Lot 165 DC - 232 Duncan Creek Rd. Lillington, NC 27546

The Apex - RH
'CRAFTSMAN'

3-27-24 - Initial Redlines- JJ

CRAWL SPACE FOUNDATION 'CRAFTSMAN'

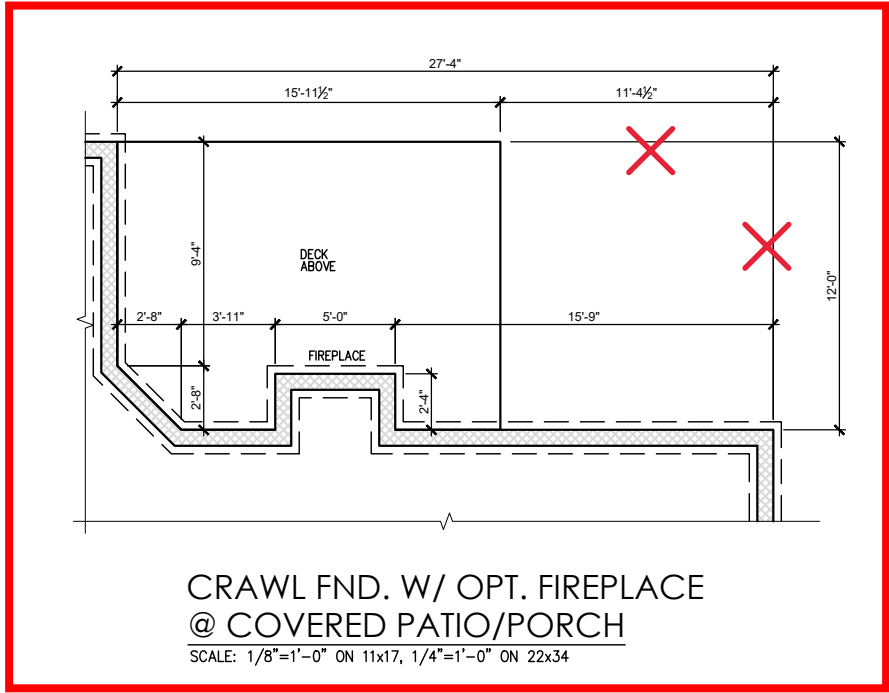
See Sheet 1.2.1c

See Sheet 1.2.2c for third car garage

See Sheet 1.2.2c for new dimensions

FIRST FLOOR PLAN 'CRAFTSMAN'

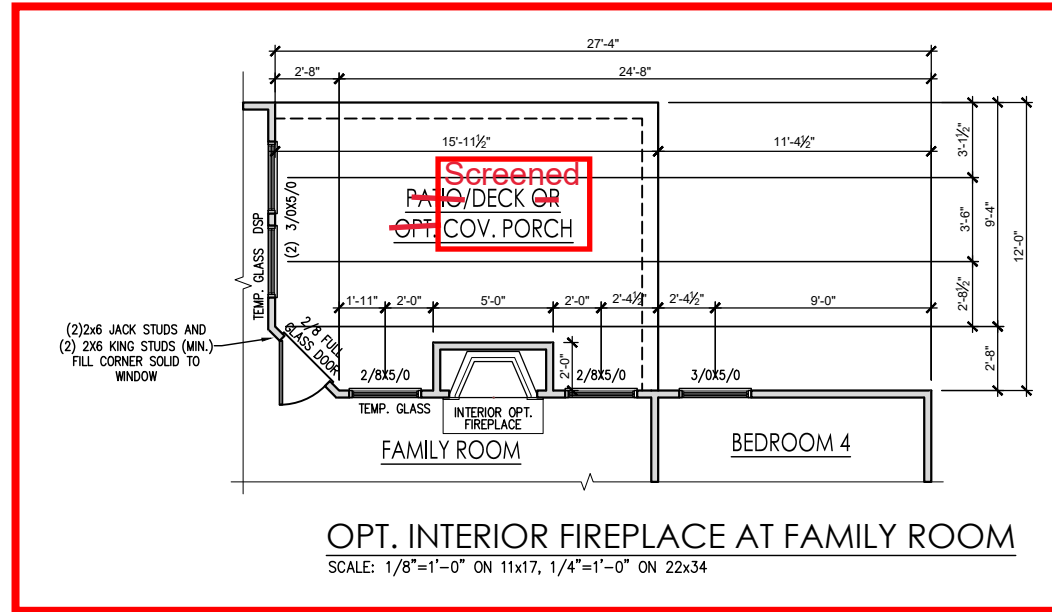
Gas Stub for stove

Include sink, NO window

Oak Treads

See Sheet 2.1.c for Fireplace and covered porch

See Sheet 2.8c for Third Car Garage & two car side entry

Install 60"x34" fiberglass shower

See Sheet 2.8c for new dimensions of garage extension at the front

**OPT. 2-CAR SIDELOAD GARAGE w/ THIRD CAR GARAGE
RIGHT SIDE ELEVATION 'CRAFTSMAN' (CRAWL/~~STEM WALL~~)**
SCALE: 1/4" = 1'-0" ON 22x34, 1/8" = 1'-0" ON 11x17

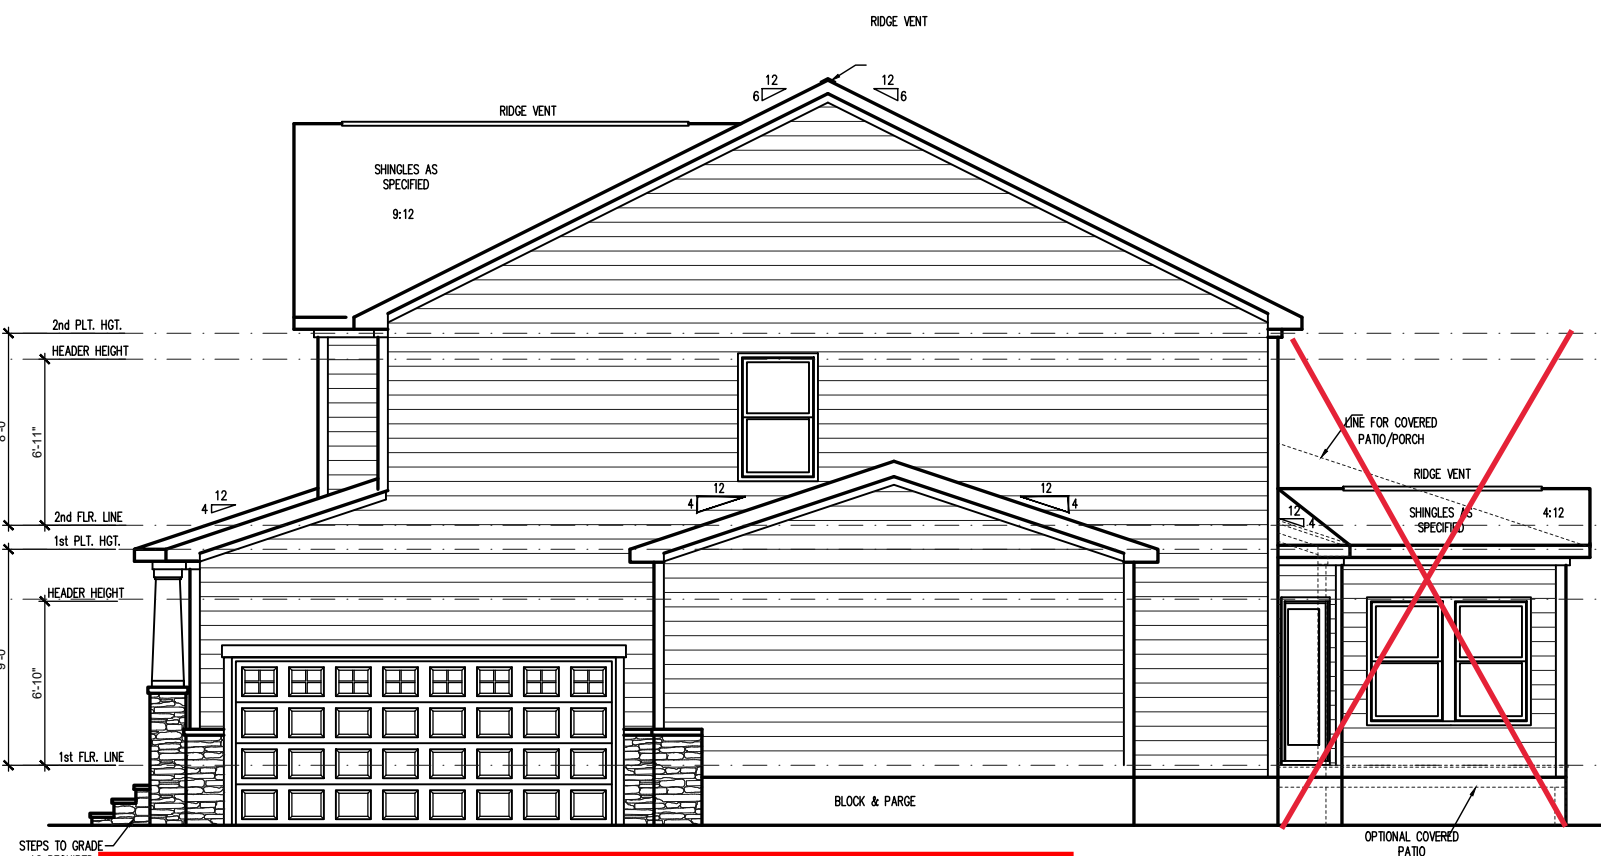
See Sheet 2.4.3c for covered porch with second floor sitting room

FRONT ELEVATION 'CRAFTSMAN' (CRAWL/STEM WALL)
 SCALE: 1/4" = 1'-0" ON 22x34, 1/8" = 1'-0" ON 11x17 SEE FOUNDATION PAGES FOR FOUNDATION TYPE

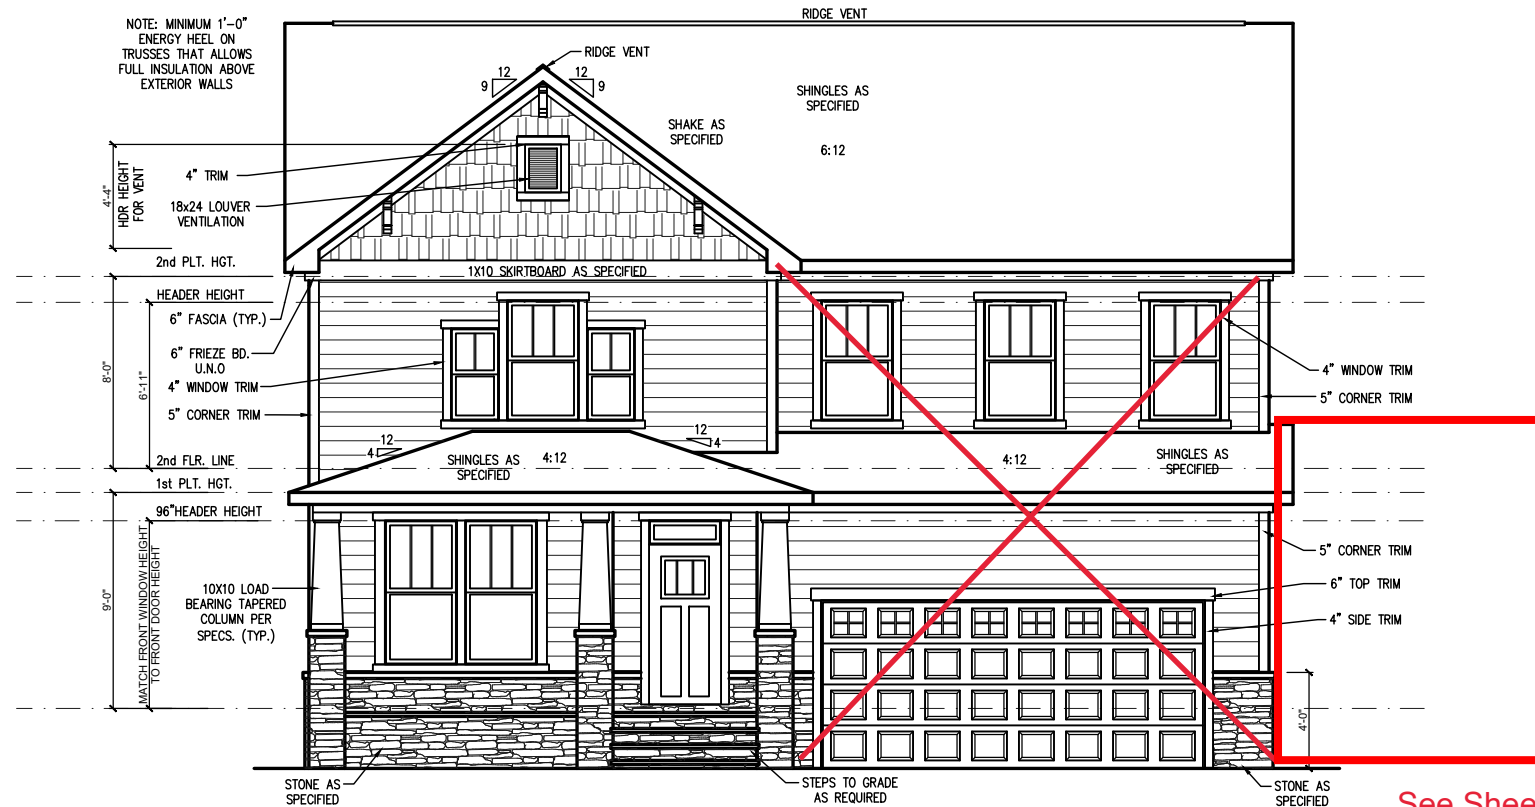
See Sheet 2.8.3 for third car garage front with 2 car side load garage

S-2.1

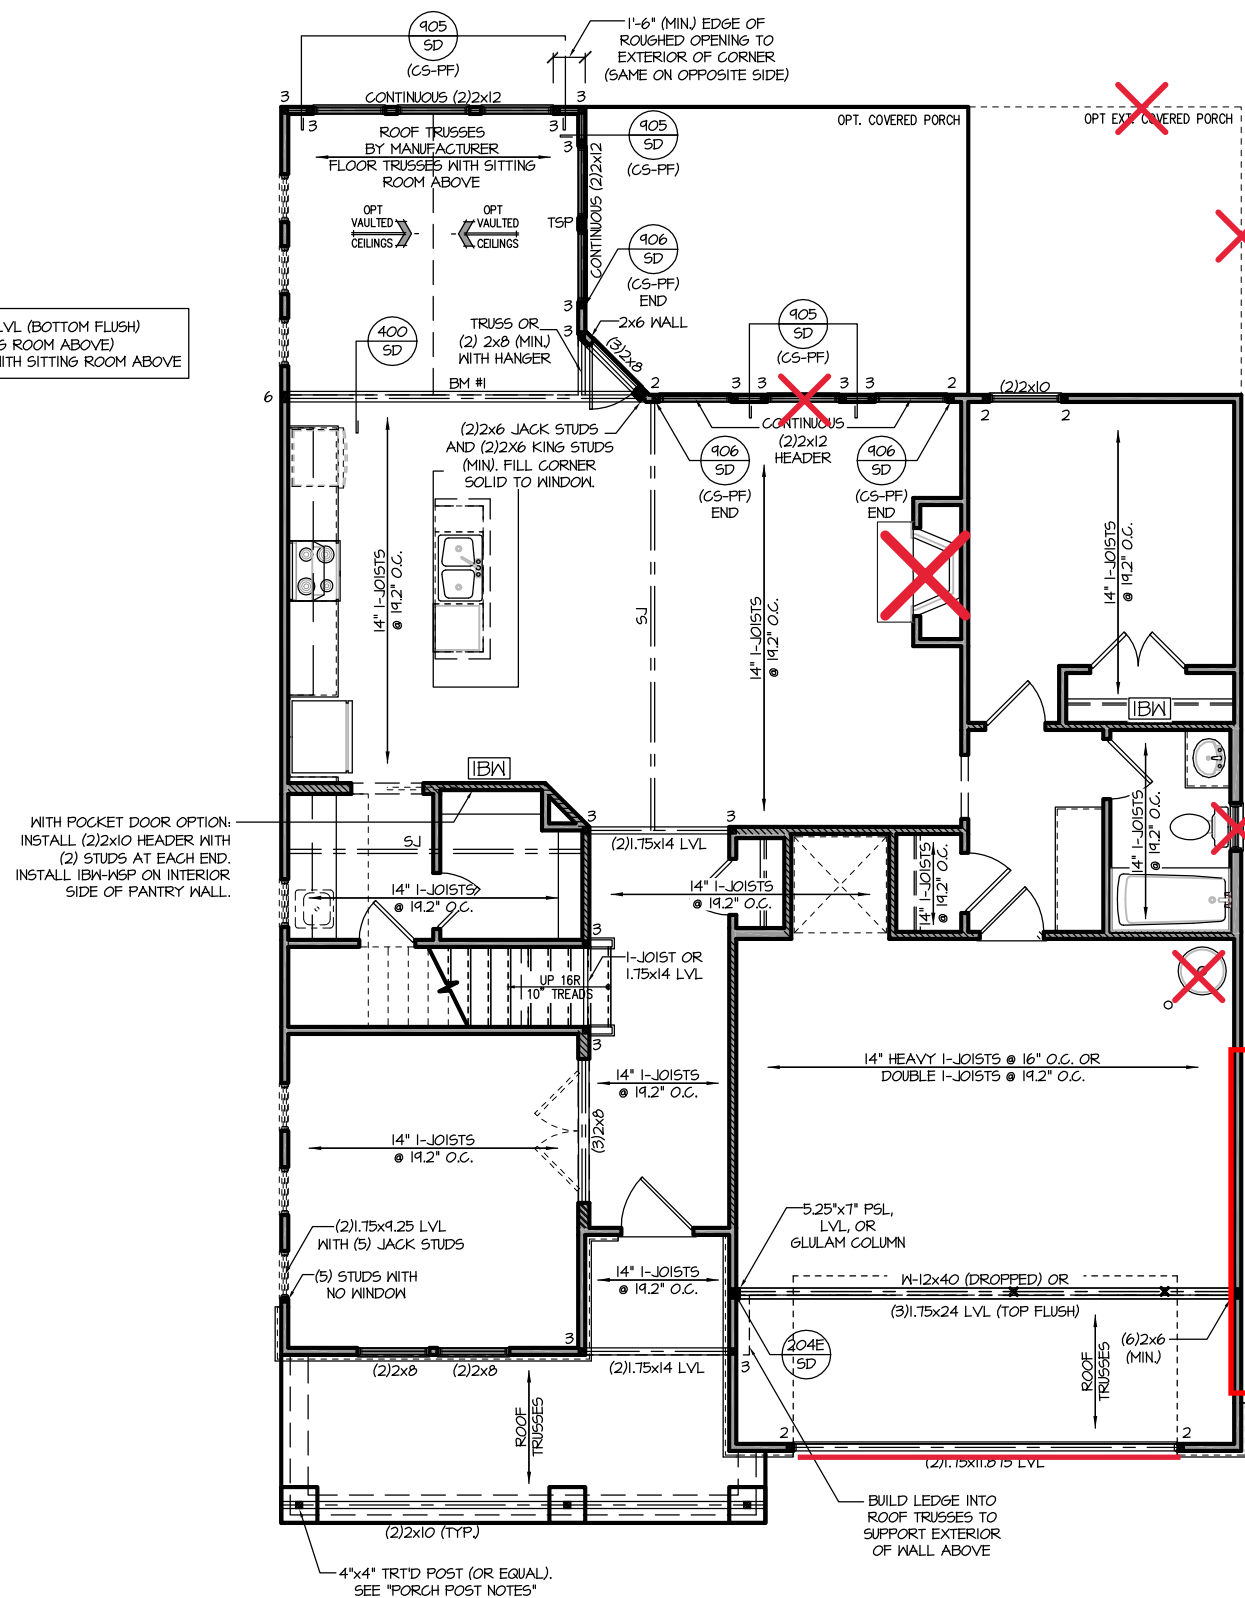
See Sheet S-1.2.1
for fireplace

see Sheet S-1.2.3
for new dimensions
abd third car garage with
2 car side entry

OPT. SITTING ROOM

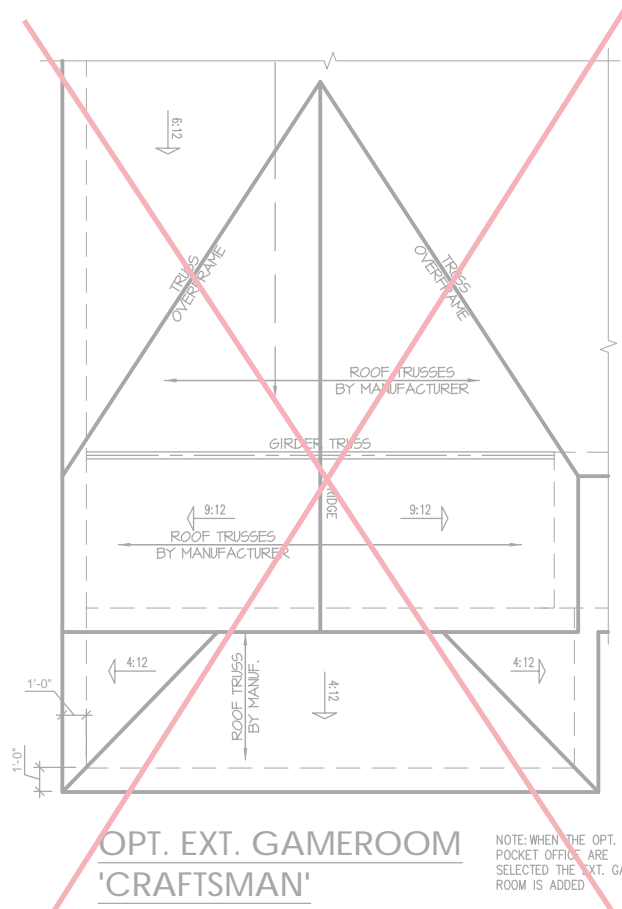
See Sheet S-3.3 for third car garage and front roof extension
